DESIGN AND CONSTRUCTION MANUAL DESIGN MODIFICATION REQUEST

PROJECT NAME: Discovery Park Phase 1

RE: PL2023011 – Discovery Park Stream Buffer Waiver

SHEET
 EX-005A

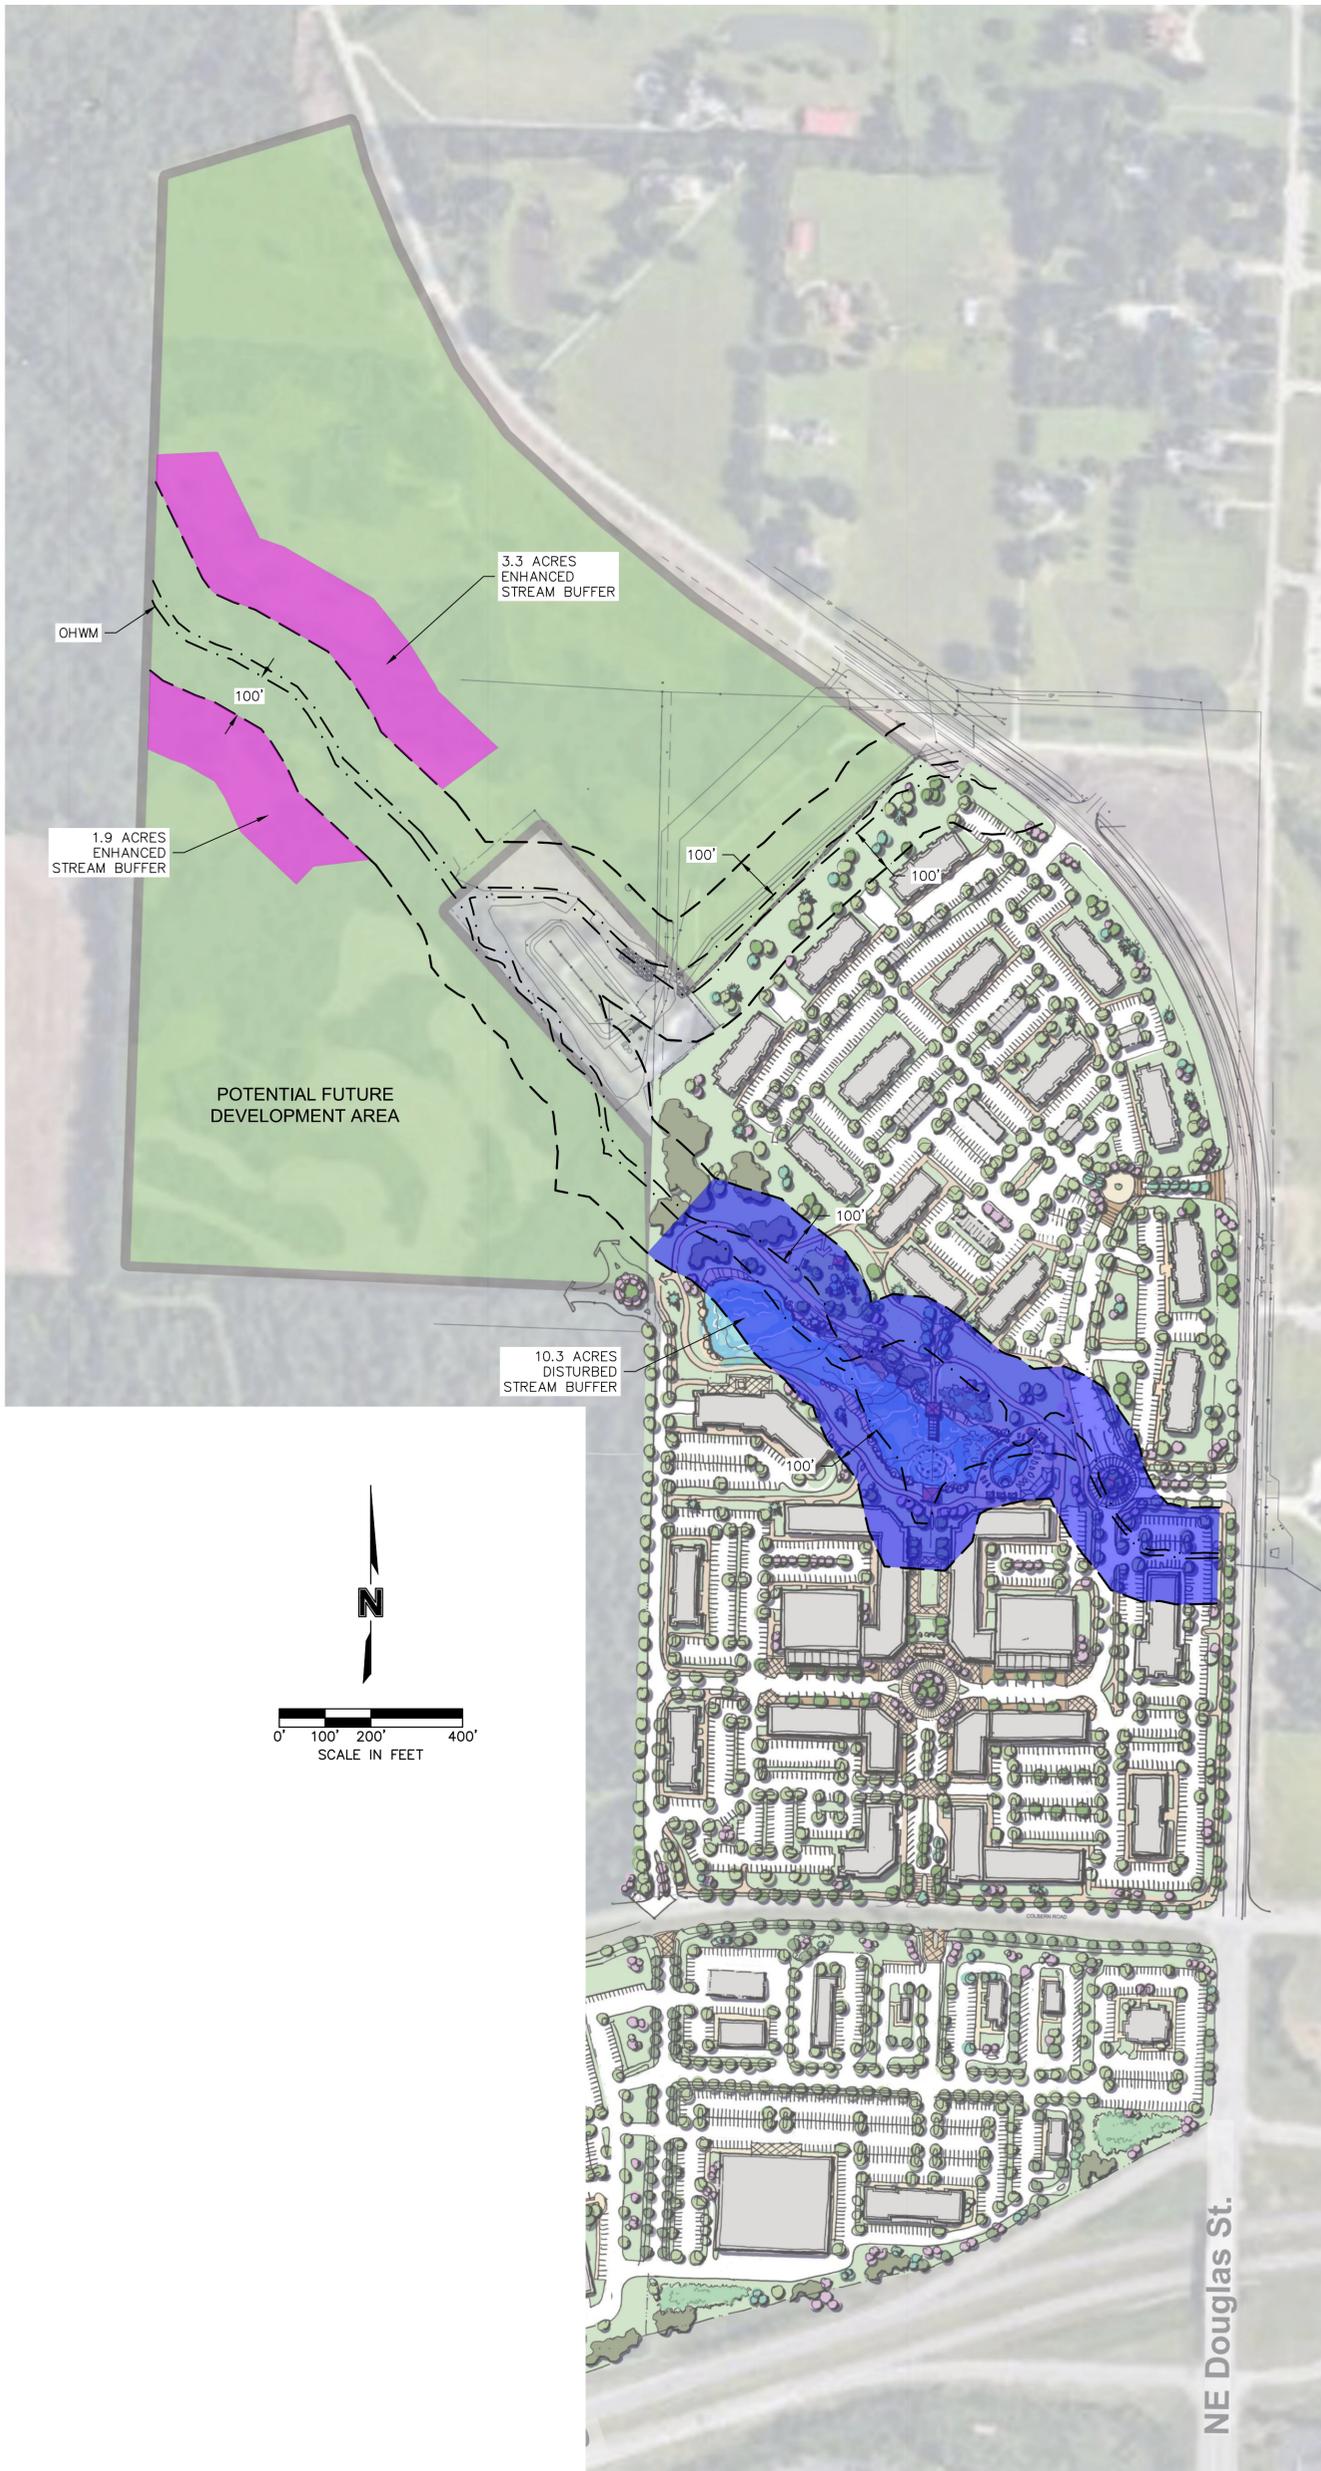
A waiver is being requested to remove 10.3 acres of stream buffer located within the project site, established as required in Section 5605.3.B of the Kansas City Metropolitan Chapter, American Public Works Association, Standard Specifications & Design Criteria, Section 5600 – Storm Drainage Systems & Facilities. Removal of the existing creek channel, as described in the attached memo, is driven by:

We are submitting this memorandum to support the attached waiver request for the Discovery Park Zone 1 & 2 development to remove 10.3 acres of stream buffer, established as required in Section 5605.3.B of the Kansas City Metropolitan Chapter, American Public Works Association, Standard Specifications & Design Criteria, Section 5600 – Storm Drainage System & Facilities, which falls at the upper-most reach of the existing native channel. An existing box culvert crossing NE Douglas Street will be extended approximately 720 feet to the proposed wet-bottom detention basin, and the existing creek channel removed.

- COMMENTS: (1) Submittal and approval of a Stormwater BMP Operations and Maintenance Manual will be required prior to issuance of a Certificate of Substantial Completion.
- (2) Native plantings and grasses along all stream buffers and detention areas will be considered a part of those BMPs and shall be included in the Stormwater BMP Operation & Maintenance Manual.
- (3) The proposed reinforced box culvert shall include a low-flow / self-cleaning channel.
